VILLAGE OF MONROE

Workshop
May 11, 2026

Village of Monroe Planning Board Review

Project: St. Rt 17M Project Supply (Gravel Lot)
Tax Lot No. 214-1-56.22
Reviewed by: David Higgins
Date of Review: May 8, 2026

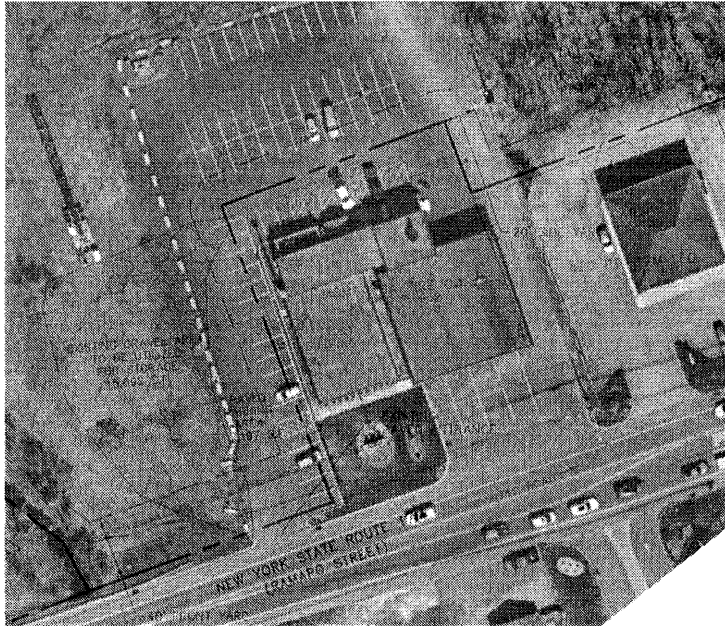
3. Based upon recent aerial imagery (April 2026), there appears to be concrete barriers placed along the edge of the existing paved driveway. (See below)

Additionally, the parking lot serving the fire company appears to be located within the subject parcel. The survey map and Site Plan map should be updated to reflect current site conditions and applicant to clarify ownership of driveway/parking areas.

3. The blocks were placed by the applicant to demarcate and it is Mr. Weinberg's understanding that it's the applicant's driveway with an easement that the survey will clarify. Chairman Parise noted that the fire company is using that also and Mr. Weinberg said the owner gifted it to them. Chairman Parise would want this put on the plan and Attorney MacCartney noted he would like to see the easement. Mr. Weinberg said they would get a survey and include the Title Report
